UNITED STATES PATENT AND TRADEMARK OFFICE

10/618,033

Office Action Summary

DETAILED ACTION

Examiner Mark-up Drawings for Kerr '925:

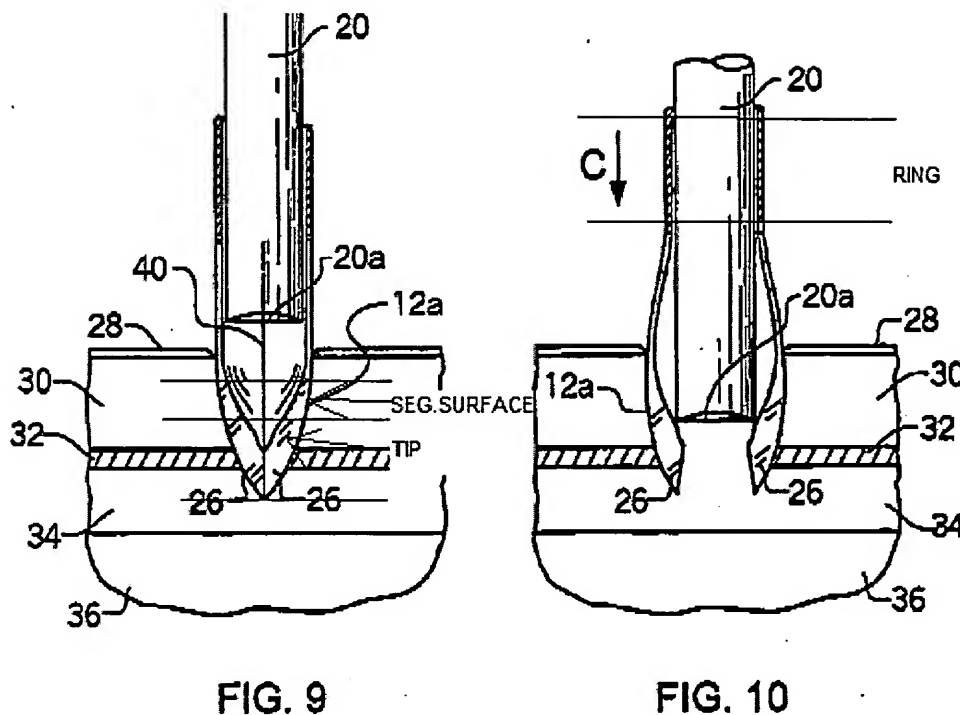
1. A device comprising: an elongated tubular body having an axis, a proximal end, a distal end and a lumen longitudinally extending therethrough (Fig 9 Item 20); and a dilating tip slidably mounted on the distal end of the tubular body (Fig 9 Item 12a) and comprising a segmented surface that is generally transverse to the axis of the tubular body, and a generally rigid tube extending distally from the segmented surface and

having a sharp distal end adapted to puncture tissue (Paragraph 57); wherein distal movement of the tubular body relative to the dilating tip exerts a force on the segmented surface to thereby open the segmented surface (Fig 9 and 10).

2. A device according to claim 1, wherein the elongated tube is generally cylindrical (Fig 9 Item 20).

3. A device according to claim 1, where the segmented surface comprises two or more segments (Fig 3).

4. A device according to claim 1, where the segmented surface comprises three or more segments (Fig 3).

5. A device according to claim 1, wherein the dilating tip further comprises a ring mounted in surrounding relation to the tubular body (Fig 10).

6. A device according to claim 5, wherein the segmented surface comprises a plurality of segments, each of which is hingedly attached to the ring (Fig 10).

7. A device according to claim 1, wherein the dilating tip is generally funnel-shaped (Fig 9 Item 26).

8. A device according to claim 1, wherein the generally rigid tube of the dilating tip is segmented (Fig 9 Item 26).

18. A device comprising: an elongated tubular body having an axis, a proximal end, a distal end and a lumen longitudinally extending therethrough (Fig 9 Item 20); a dilating tip slidably mounted on the distal end of the tubular body (Fig 9 Item 26) and comprising: a ring mounted in surrounding relation to the distal end of the tubular body (proximal portion of Item 12); a segmented surface that is generally transverse to the axis of the tubular body, the segmented surface comprising three or more segments, each segment being hingedly attached to the ring (Fig 9 and 10); and a generally rigid tube extending distally from the segmented surface (Fig 9 Item 26), the tube having a sharp distal end adapted to puncture tissue (Paragraph 57) and being segmented into three or more segments (Fig 3); wherein distal movement of the tubular body relative to the dilating tip exerts a force on the segmented surface and the generally rigid tube to thereby open the segmented surface and the generally rigid tube (Fig 9 and 10).
